***Response to Additional Interrogatories from Synapse Energy Economics
On-Island Capacity for Security of Supply Project (UE20742)***

**RESPONSES TO ADDITIONAL INTERROGATORIES
FROM
SYNAPSE ENERGY ECONOMICS**

**On-Island Capacity for Security of Supply Project
(UE20742)**

Interrogatories to MECL – E3 Report and MECL Portfolio NPV Study (Exhibit C-33)

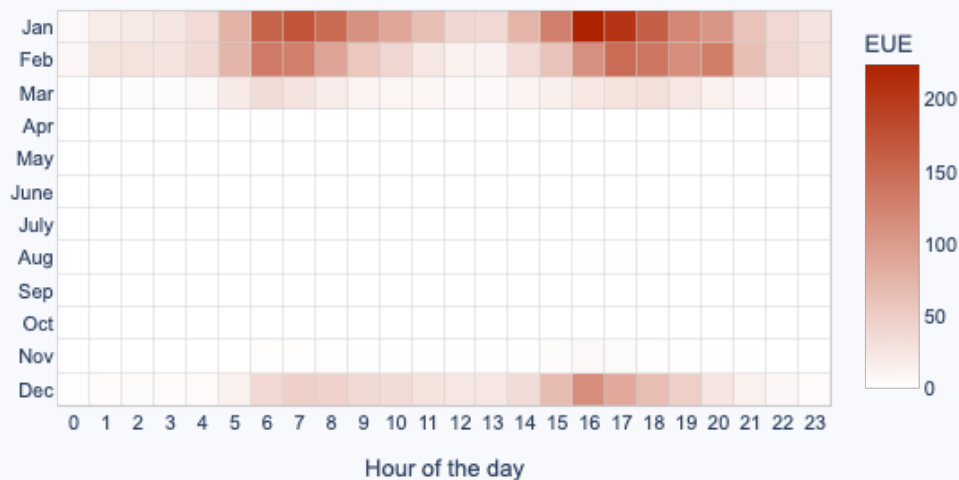
IR-3c. If Figure ES-2 is reflective of the risk before additional capacity, what is the associated 2030 value of LOLE (in days/year) associated with the EUE heat map data seen in Figure ES-2? Provide the distribution of LOLE across the 365 days of 2030.

IR-3d. If Figure ES-2 is reflective of the risk after 115 MW of perfect capacity is added, confirm that the modeled system in 2030 after the 115 MW of perfect capacity added reflects an LOLE value of 0.1 days/year. Provide the LOLE distribution across the 365 days of 2030.

Response: Figure ES-2 is reflective of the risk after additional perfect capacity is added.

Response: Confirmed. For data see IR-3b.
